March 7, 2025

Version 1

Product Update: 2024 ZDX Multi-View Display Reversed

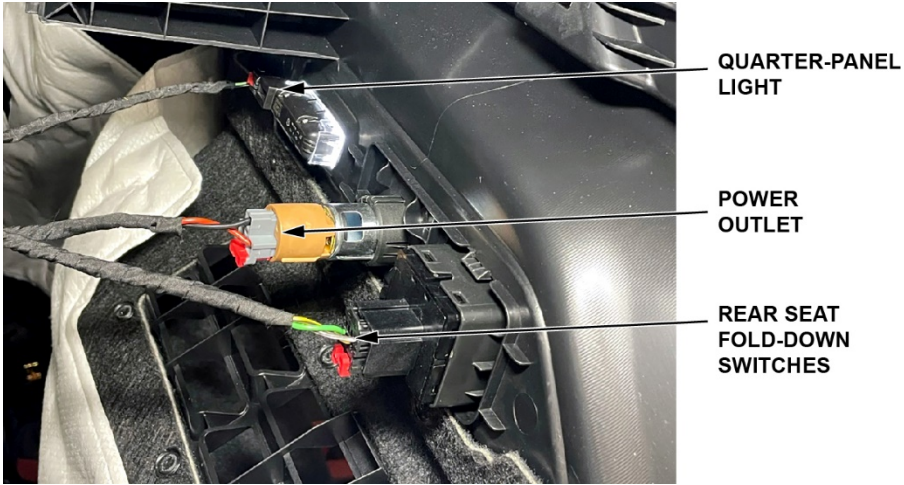
1. Turn the vehicle to the ON mode.
2. While holding the brake, place the vehicle in REVERSE.
3. Hold your left hand under the driver's side sideview mirror, then verify that it appears on the left side of the Surround Vision multi-view display.

Hand should appear here.

If hand is appearing here, complete the repair procedure.

Does your hand appear on the left side of the vehicle image on the Surround Vision multi-view display?

Yes –The vehicle is operating as designed; no further action is required.

No – Proceed to the REPAIR PROCEDURE.

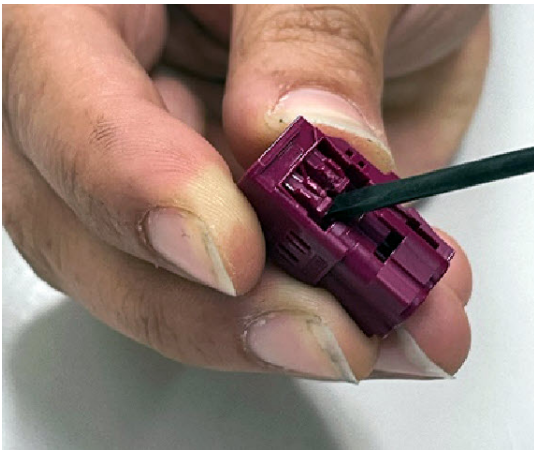
7. Remove the #3 lower terminal by gently lifting the terminal locking tab, then pull the terminal out.

- Only very slight lifting of the locking tab is necessary.
- **Do not** apply too much force or movement or it will break the connector.
- **Do not** remove terminals 1 and 2.

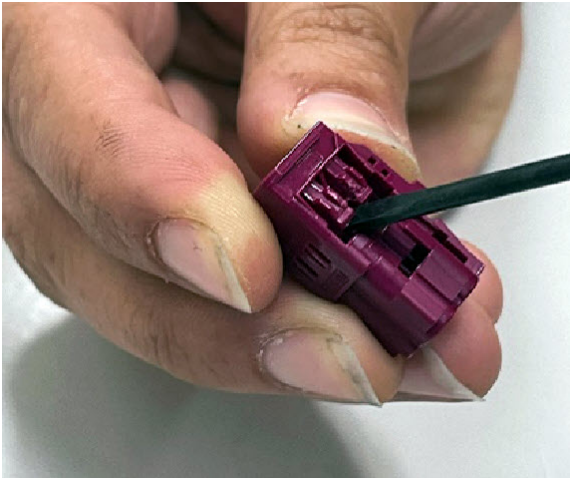
9. Remove the #4 lower terminal by gently lifting the terminal locking tab, then pulling the terminal out.

- Only very slight lifting of the locking tab is necessary.
- **Do not** apply too much force or movement or it will break the connector.
- **Do not** remove terminals 1 and 2.

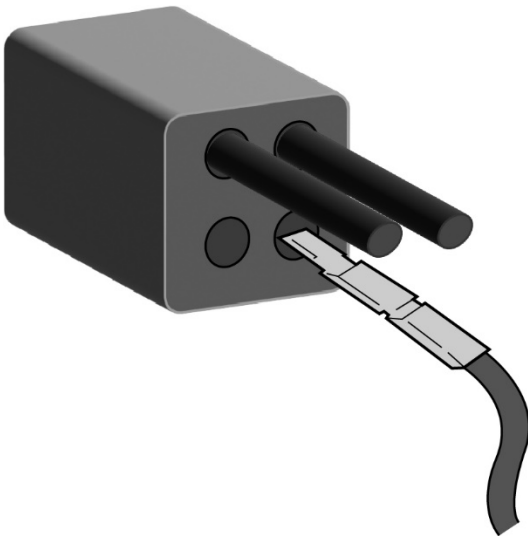
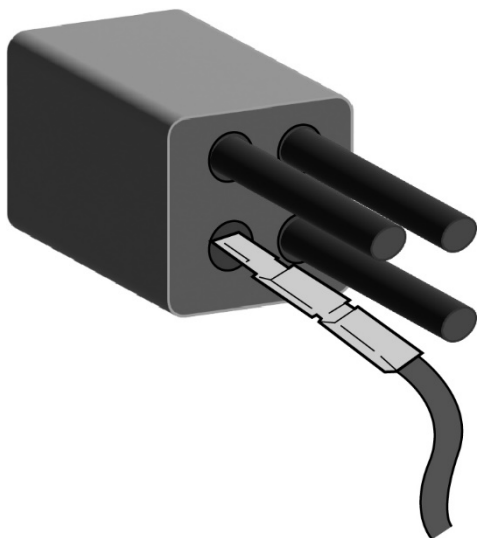
10. Insert the #4 terminal into the #3 connector slot and push in until it clicks. Lightly pull on the wire to confirm the terminal is locked into the connector.

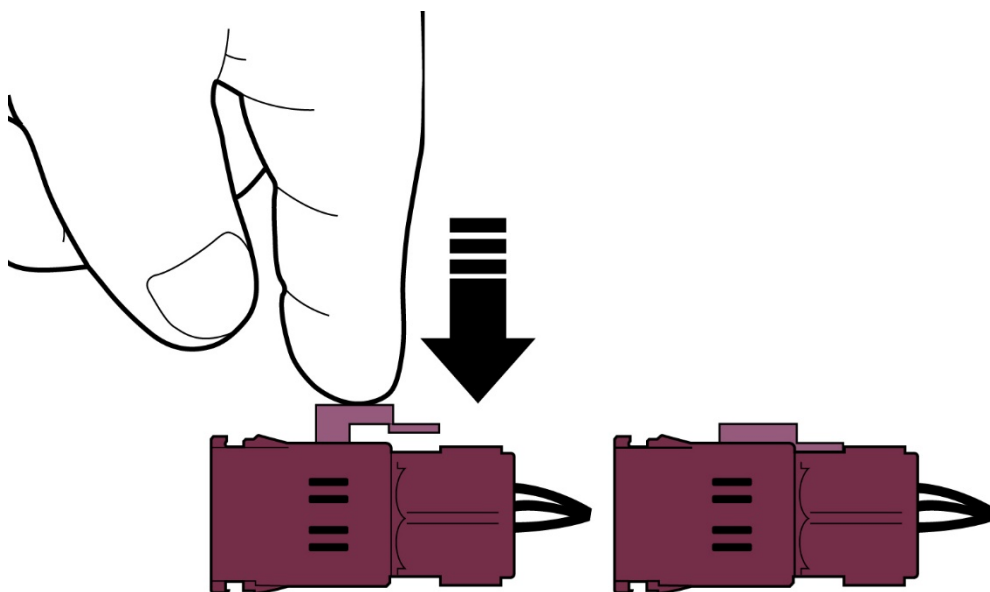
11. Insert the #3 terminal (marked with tape) into the #4 connector slot and push in until it clicks. Lightly pull on the wire to confirm the terminal is locked into the connector.

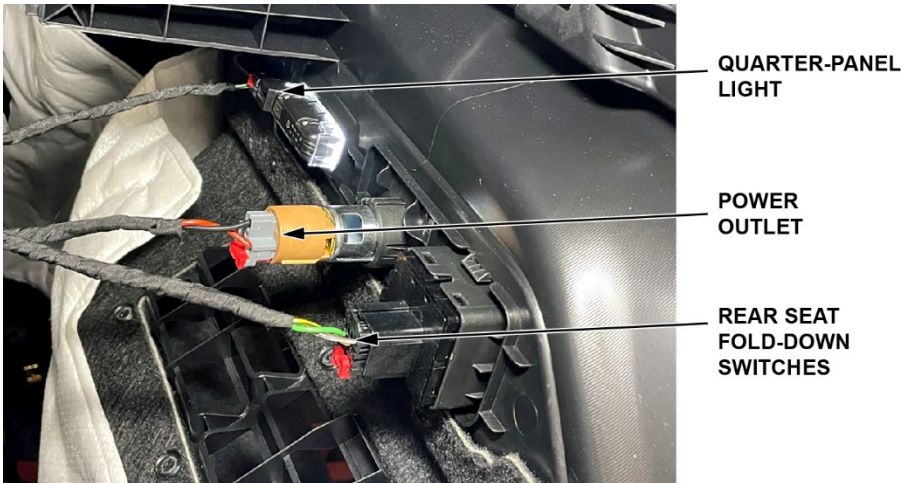
2. Hold your left hand under the driver's side sideview mirror, then confirm that it appears on the left side of the in-car multi-view display. This confirms the connector wiring is correct.

Hand should appear here.

If hand is appearing here, complete the repair procedure.
